CAN-0031

CAN-0031: CIP-006 (No Version Supplied) Requirement R1 – Acceptable Opening Dimensions

MidAmerican Energy Company Comments on NERC Compliance Application Notice (CAN) CAN-0031

PROJECT TITLE: Draft CAN-0031: CIP-006 R1 Acceptable Opening Dimensions - As posted on 9/23/2011

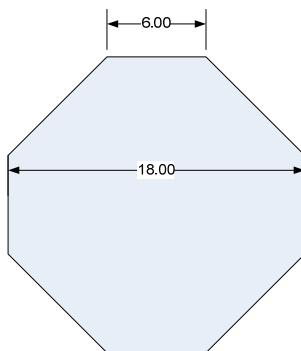
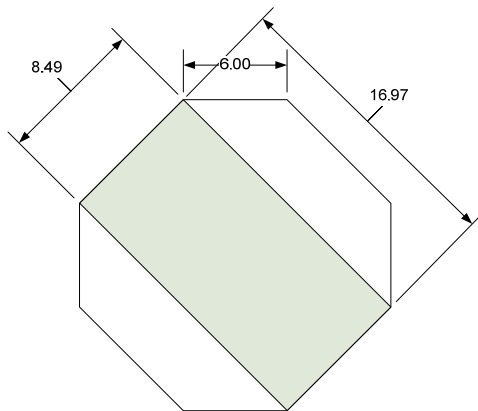
2. The second issue is, BPA feels that the CAN is unclear on the relationship between maximum total area and length of the shortest side. The examples make the intent of the CAN clear, so this is clearly an oversight. However, the examples are just that; examples, not direction.

In particular, there are two statements on page 2 of the CAN that address permissible sizes:

1. Replace the first statement on page 2

CEAs are to consider 96 square inches as the measurement for each maximum acceptable opening without physical protective measures in place with

CEAs are to consider physical protective measures to be required for an opening if it is possible to enclose a 6 by 16 inch rectangle in the opening.

Note that this incorporates the 96 square inch maximum size: any opening capable of enclosing a 6 by 16 inch opening would be at least 96 square inches.

2. Delete the second statement starting “Additionally, for ...”

3. Add the following example.
